STAFF RECOMMENDATION
503 and 505 Buchanan Street
June 19, 2019

Application: New construction—Infill and Outbuilding;
District: Salemtown Neighborhood Conservation Zoning Overlay
Council District: 19
Map and Parcel Number: 08108046600 and 08108046500
Base Zoning: R6
Applicant: Kent Basile
Project Lead: Melissa Baldock, melissa.baldock@nashville.gov

Description of Project: Infill construction of new residences and detached carports on two vacant lots.

ROOF LAYOUT

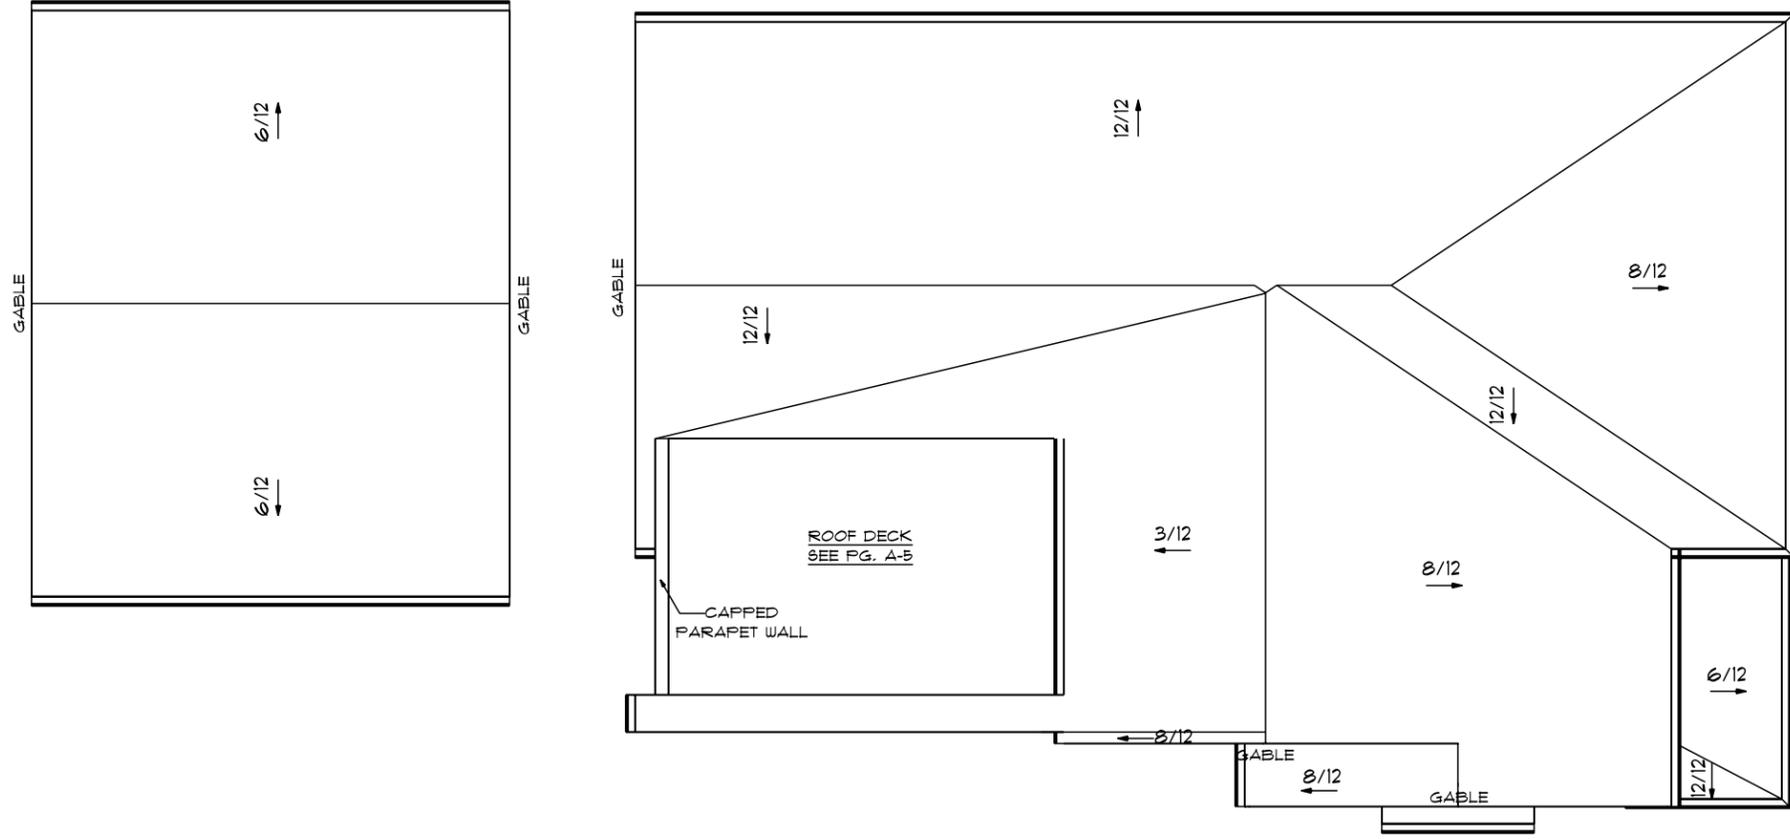
Roof form: The roofs of the infill houses have various roof forms. On the right-hand side is a 12/12 hipped form. The main form of the left-hand side is a side gable with an 8/12 pitch. Also on the right side is a long, 3/12 shed roof. The shed roof conceals the rear rooftop deck, as MHZC has required that rear rooftop decks be surrounded by roof on at least three sides. Staff finds that while the roof form does meet the design guidelines, it could use some simplification, particularly on the left side. Staff is willing to work with the applicant on simplifying the roof design while still meeting the design guidelines.

Staff finds that the project meets section III.E of the design guidelines.

FRONT ELEVATION

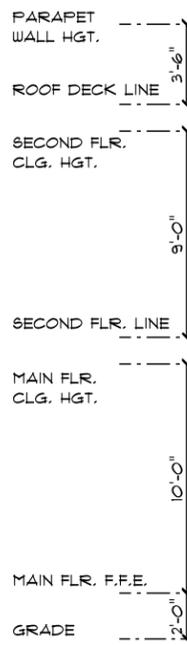
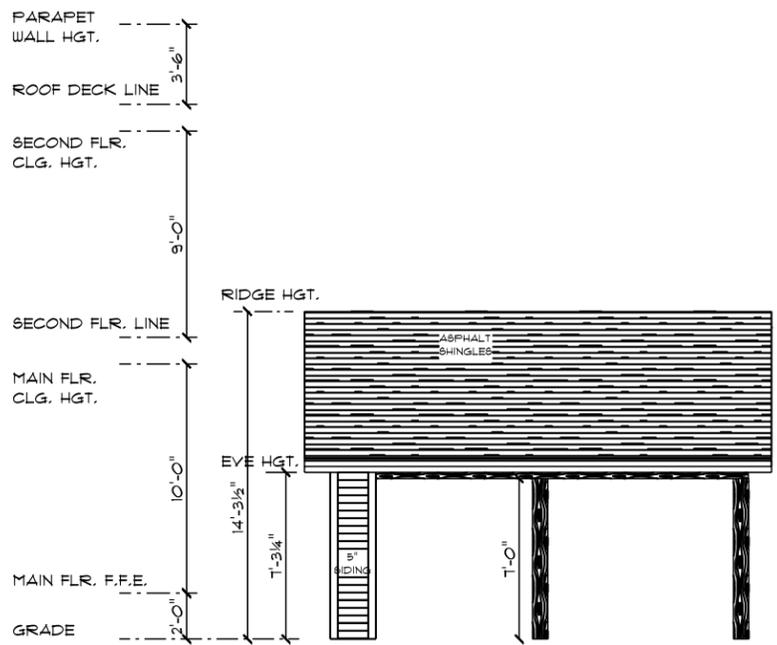
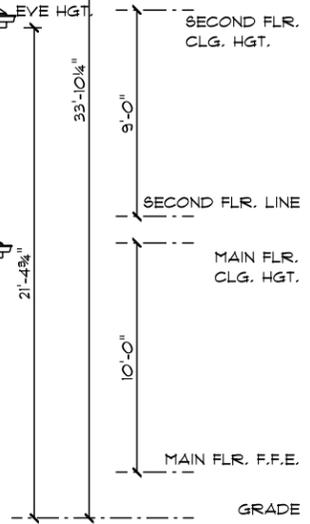
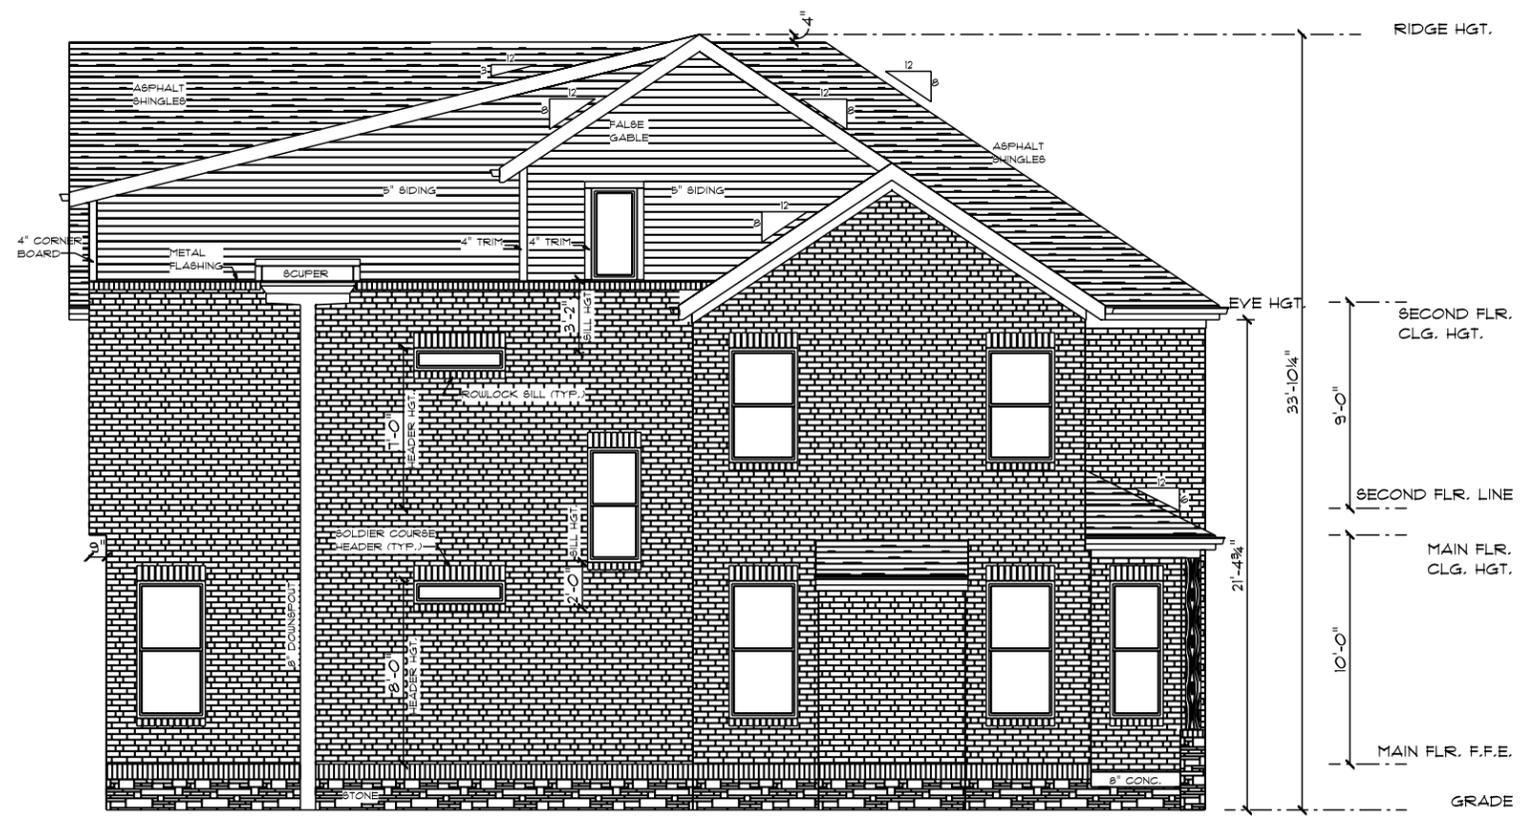
* Although brick and siding are appropriate cladding materials, staff notes that the change in materials typically happen at the floor line. However, the drawings show that on the front façade, left side, the second story is lap siding, but at the corner, the material transitions to brick on the second story. This type of material transition is not something you see historically and can create an awkward material change. Staff recommends that any material change happen at the floor level rather than from one façade to the next.

** The front porch posts are drawn as if they are rough wood. Staff recommends that the wood posts be milled smooth and painted.

With the conditions that material changes happen at the floor level; the front porch posts are milled smooth and painted; and that staff approve a brick sample, stone sample, roof color, and all windows and doors, staff finds that the project meets Section III.D of the design guidelines.
